Subject: VIRGIL C. SUMMER NUCLEAR STATION  
DOCKET NO. 50/395  
OPERATING LICENSE NO. NPF-12  
TRANSMITTAL OF EMERGENCY PLAN PROCEDURE CHANGES

EMERGENCY PLAN PROCEDURE  
 EPP-005  
 OFFSITE DOSE CALCULATIONS  
 REVISION 19

EMERGENCY PLAN PROCEDURE  
 EPP-052  
 EMERGENCY INFORMATION PLAN  
 REVISION 1

# RM-G19 CORRECTION FACTOR

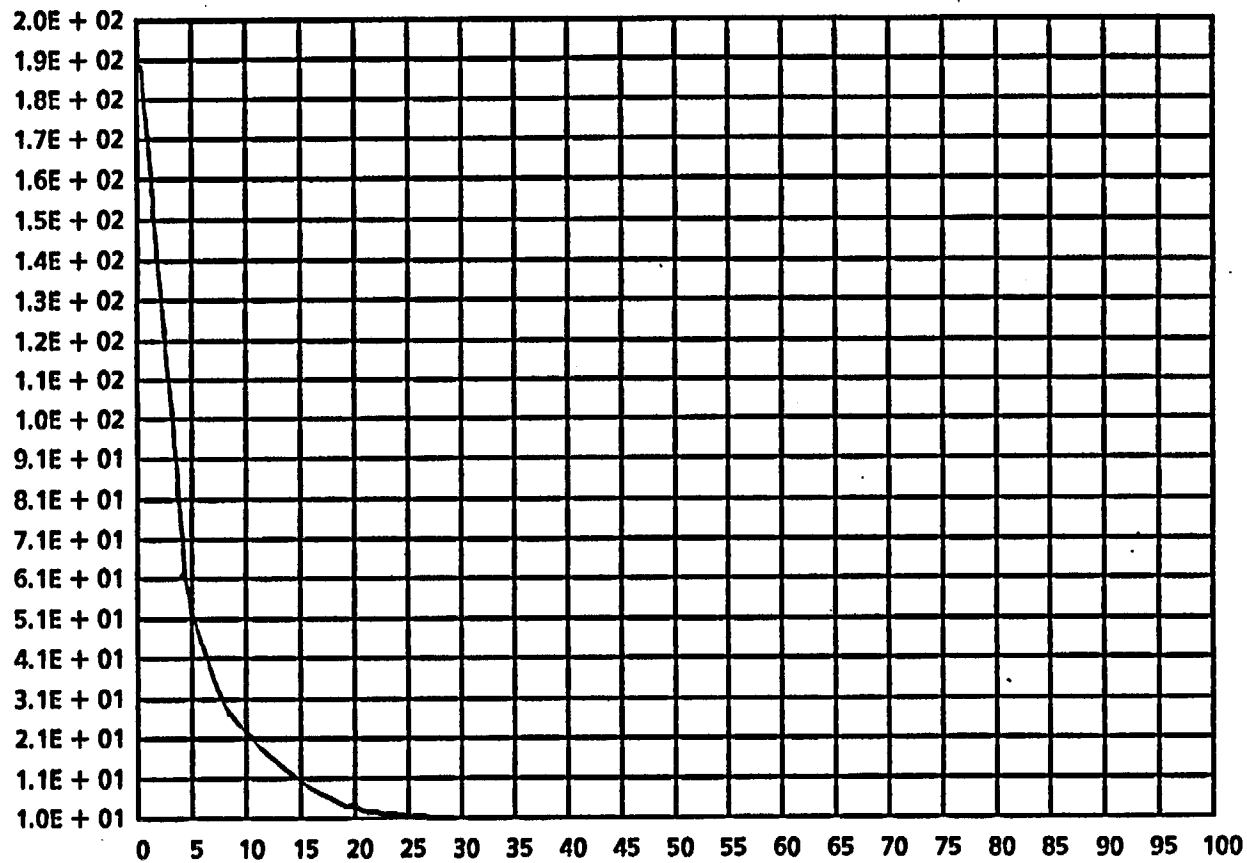
C  
O  
R  
R  
E  
C  
T  
I  
O  
N
